Gnarabup Tourism Development

Saracen Properties Pty Ltd representing 5 Star Margaret River Pty Ltd and The Beach Village Pty Ltd.

Report 1782 May 2025 This assessment report has been prepared by the Environmental Protection Authority (EPA) under s. 44 of the *Environmental Protection Act 1986* (WA). It describes the outcomes of the EPA's assessment of the Gnarabup Tourism Development proposal by Saracen Properties Pty Ltd (representing 5 Star Margaret River Pty Ltd and The Beach Village Pty Ltd).

Figure 2: Conceptual development layout for the proposal (Emerge Associates, 2024)

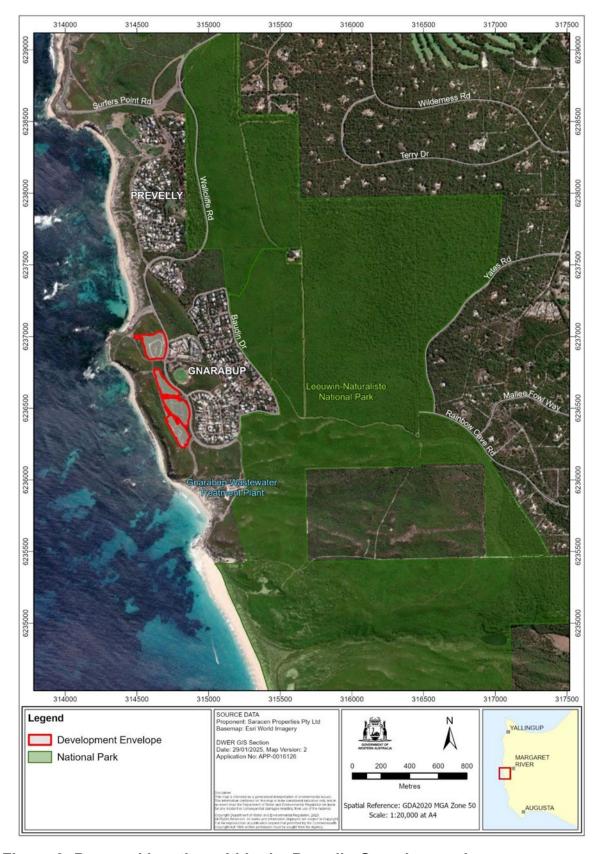
The development envelope includes a registered Aboriginal heritage site (AHS) (ID: 17093) comprising a 37 centimetre (cm) wide, 25cm deep 'gnamma hole' (Figure 2). Gnamma holes are natural cavities formed in hard rock (often granite) that provide natural water storage. The location of the AHS was confirmed by Traditional Owners and ethnographic consultants during a visit to the proposal development envelope. It is understood that the Traditional Owners recommended an exclusion area of 7 metres (m) around the AHS to protect the site. In 2021, the Department of Planning, Lands and Heritage (DPLH) added the AHS, inclusive of a 7m buffer, to its registered sites records in the Aboriginal Cultural Heritage Inquiry System database.

The EPA considered that direct impacts to the registered AHS would likely be avoided through the implementation of the proponent's conceptual design/layout for the development envelope, which locates the AHS outside the future development area within planted open space (Figure 2). Notwithstanding, whilst the EPA notes the proponent's intent to avoid direct disturbance of the AHS, the proponent has defined the proposal as clearing and development of the entirety of the 8.1 ha development envelope. The proponent's PCD (Table 1) has not specifically exempted or excluded the AHS from disturbance required to implement the proposal.

- design/layout of the future development to avoid direct clearing or removal of the registered AHS (including the 7m buffer (radius))
- exclusion of significant ground disturbance works (excavation, rock breaking, compaction) from the proposed 'village site' area, within which the AHS is located
- implementation of standard fencing and demarcation measures around the AHS and buffer during construction works (to be confirmed in consultation with Traditional Owners)
- preparation of a Construction Environmental Management Plan (CEMP), to set out clearing procedures and guide management of ground disturbance works in close proximity to the AHS
- consultation with the Traditional Owners prior to the clearing of vegetation, and opportunity for monitoring of clearing and earthworks by a traditional owner representative.
